Report to the Future Melbourne Committee

**Planning Permit Applications: TP-2018-1005 and 46 others
Address: Various road reserves in Melbourne and Carlton**

16 May 2023

Proposed Site Plan of Cabinet 33 [Source: Applicant]

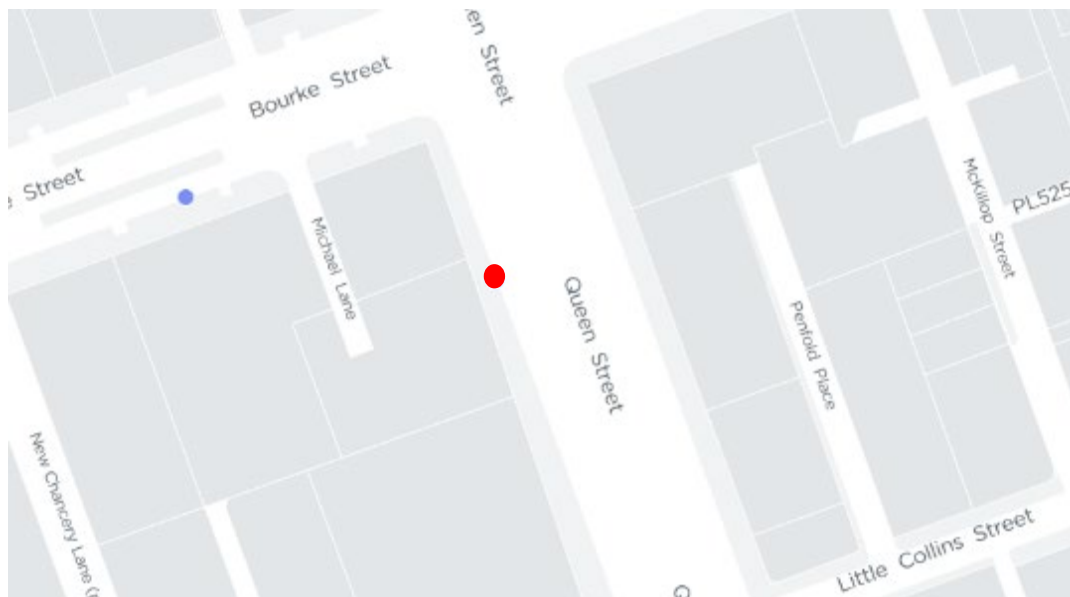
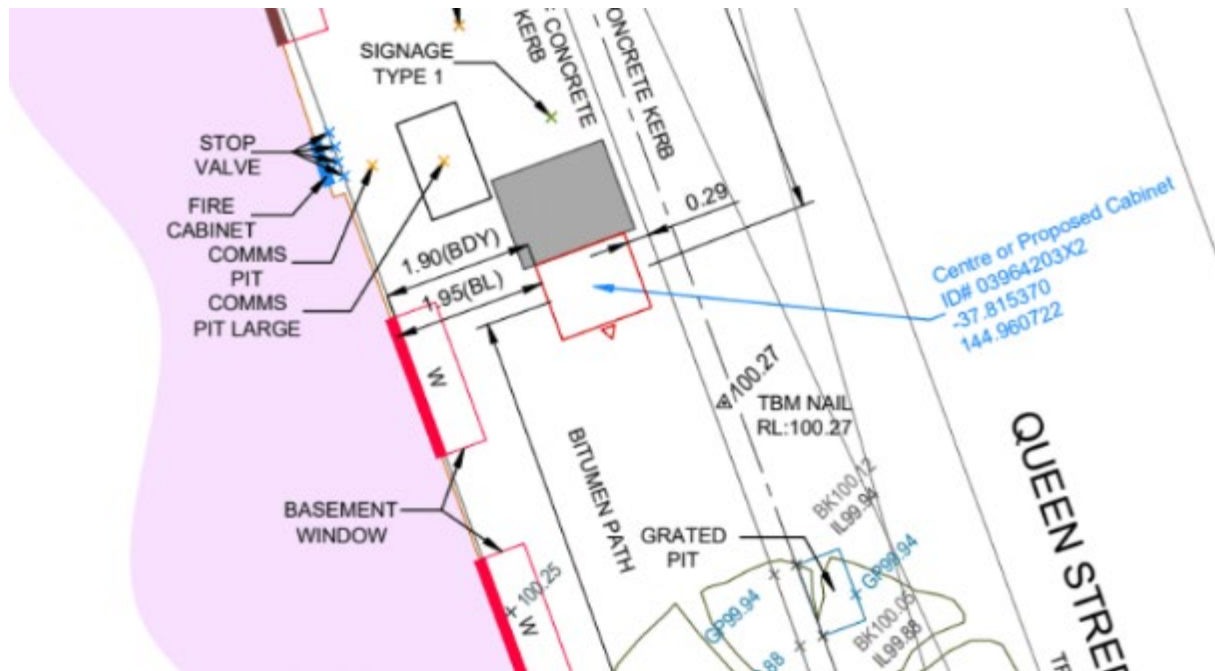
The proposal includes both a reorientation and relocation of the cabinet from the existing location further south. This section of footpath is relatively narrow and the proposal will result in a footpath width of 1.9 metres from the adjacent property boundary (1.95 metre to the building line). This clearance increases the incursion of the existing infrastructure zone upon pedestrians, noting the southern-most bus shelter indicated on the plans has an entirely cantilevered canopy which allows pedestrians to traffic under. This location represents a high use pedestrian environment due to the bus stops and surrounding land uses. A minimum of 2.4 m footpath width is required in this location to provide an acceptable outcome.

The proposed offset from the back of kerb at 290 mm is marginal and below the minimum requirements for Council infrastructure. The plans indicate the cabinet would sit closer to the kerb alignment than the bus shelters and may conflict with swept path of a bus arrival

The cabinet has been sited between the two building entries however the constrained footpath width will place the structure in close proximity to the semi-basement windows which provide the outlook and interaction to the adjacent Turf Bar hotel. The reorientation of the structure compared to the existing cabinet, its relocation adjacent to the Red Spice Road blade sign and closer proximity to the bus shelters will create highly cluttered public realm environment.
